Conceptual Review Agenda

Schedule for 07/18/16 to 07/18/16

4235 S College Ave Car Wash

Please see the following summary of comments regarding the project request referenced above. The comments offered informally by staff during the Conceptual Review will assist you in preparing the detailed components of the project application. Modifications and additions to these comments may be made at the time of formal review of this project. If you have any questions regarding these comments or the next steps in the review process, you may contact the individual commenter or direct your questions through the Project Planner, Ted Shepard, at 970-221-6343 or tshepard@fcgov.com.

CONCEPTUAL SITE PLAN

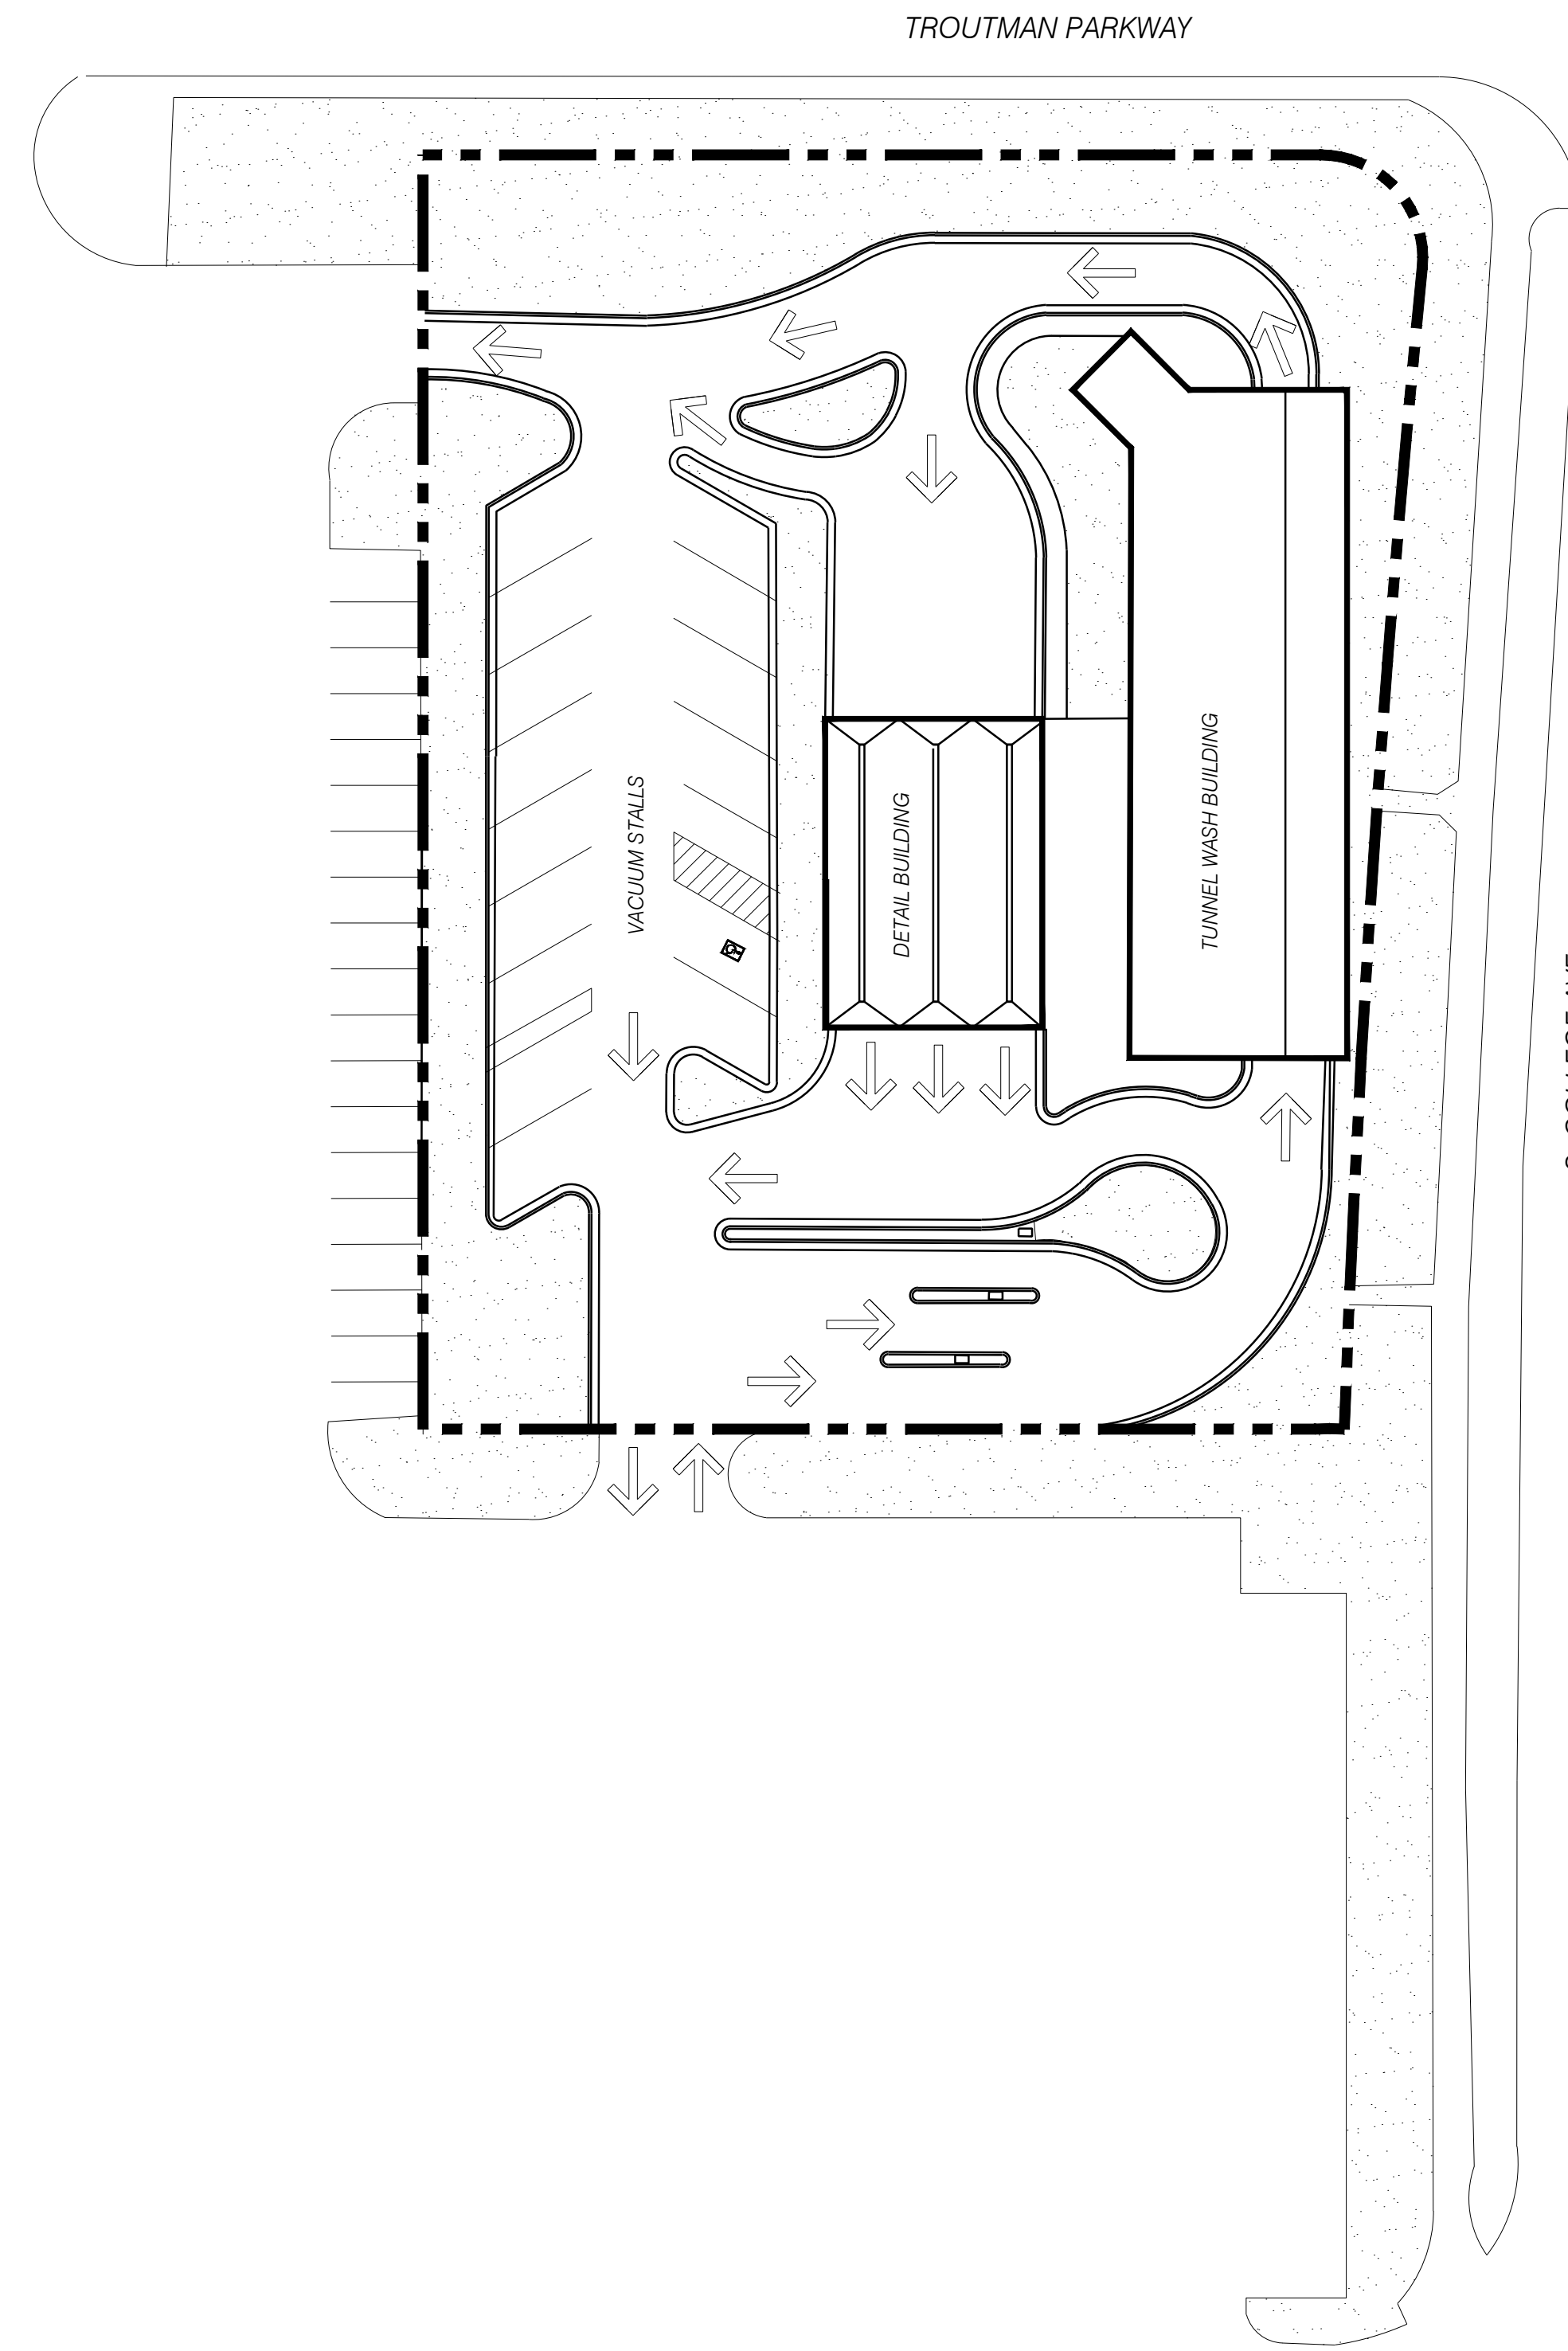
occupy such a prominent location at the corner of a major arterial street and collector street. Most of Planning comments, therefore, are focused on mitigating the overall design and aesthetics of the proposed project.

2. For example, the vacuum air distribution devices must be painted a neutral earth-tone, not a bright or reflective color as utilized at the existing facility. At the time of submittal, please provide a color chip of the selected color for these devices.

6. The site benefits from existing mature trees. All existing trees must be retained to the maximum extent feasible. This means that trees can be removed only if no feasible and prudent alternative exists, and all possible efforts to comply have been undertaken. The applicant must consider site plan adjustments, such as the location raised concrete islands, vertical curbs and equipment placement, in order to accommodate mature healthy trees. All existing trees must be graphically indicated on the Landscape Plan.

11. Section 3.2.1(E)(4) requires the perimeter of the vehicular use areas to be landscaped. As noted, the perimeter of the site must carry the burden of complying with minimum required landscape standards. For example, a dense screen of evergreen trees must be planted along College Avenue to screen the cars and headlights facing east that are queuing to enter the tunnel wash building.

15. The same comment applies to the west property line.
16. The southeast corner of the building appears to touch the east property line. Generally, along South College Avenue, there is a 15-foot wide utility easement located behind the property line. Please check to make sure there is no building encroachment over any existing
